STAFF REPORT

APPLICATION CSPA 1998-LE-048

APPLICANT: Metropark 2345, LLC

Comprehensive Sign Plan Amendment

Signage “Type D”

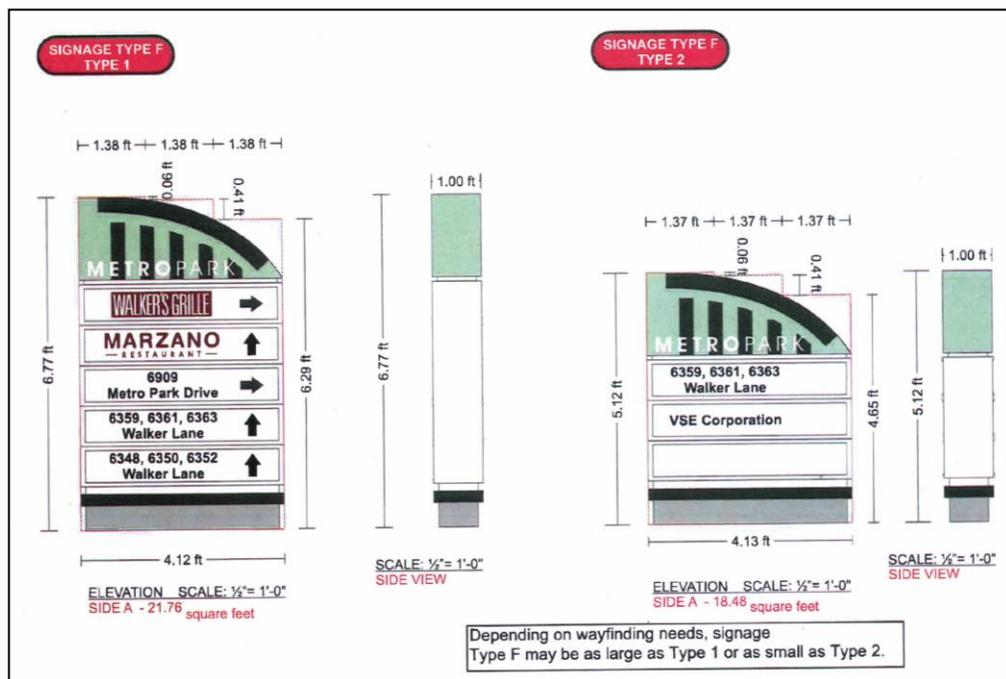
With regard to signage “Type D”, the applicant is simply requesting additional flexibility in the location on which to place previously approved building-mounted signage based on current tenants. The applicant will also remove signage from locations no longer necessary. Specifically, the applicant will remove the location of potential signage above the 2nd floor of Building 3. Next, the applicant will add a location for tenant signage above the 4th floor and to extend the location of restaurant signage on the 1st floor of Building 6. Finally, the applicant will add a location for signage on an existing restaurant canopy on Building 8. No increase in the previously approved sign area is proposed.

Details regarding the proposed building-mounted signage and corporate logos have not been provided. In order to ensure the signage does not conflict with the overall design and function of the development, staff recommends the continuation of the previous development conditions, which limit the size and number of signs in such a way to ensure the signs compliment and not conflict with the overall development. Specifically, staff continues to recommend limitations of the maximum size of single building-mounted signage (200 SF), how many signs can be placed on the elevation of a building, and the maximum square footage of signs that can be placed on a building.

**Signage Type F
Freestanding On-Site Directory Signs**

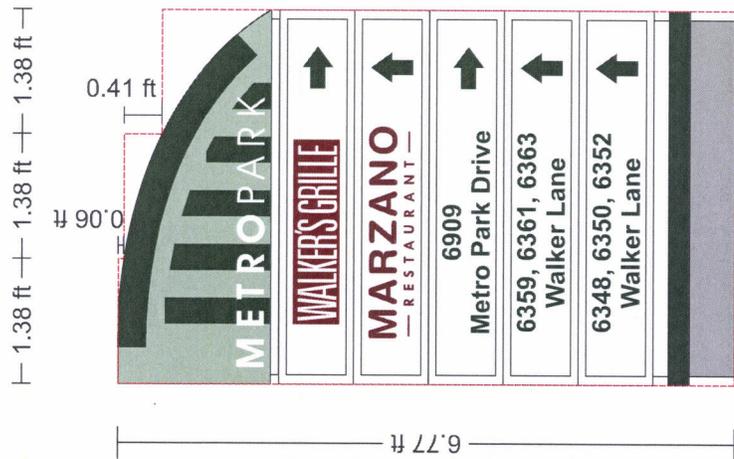
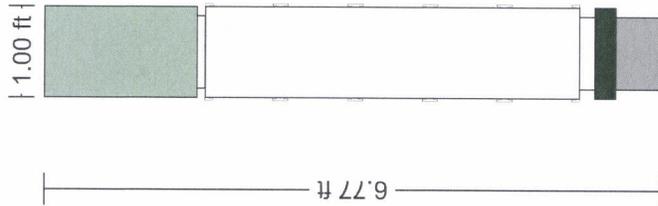
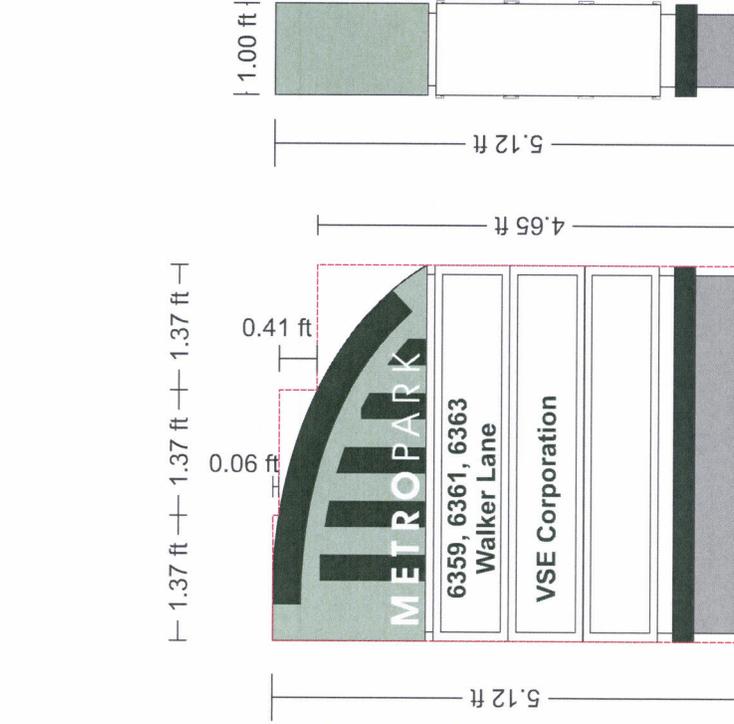
While the proposed size range for the “Type F” signs will exceed the maximum 15 SF permitted under Article 12 of the Zoning Ordinance, staff believes the proposed signage will be compatible with the overall design and function of the development and assist visitors to the site as they navigate multiple decision points on site. The applicant has submitted drawings demonstrating that the proposed sign locations will not create sight distance, utility easement, or other facility conflicts. Therefore, staff has no issues with the proposed modifications.
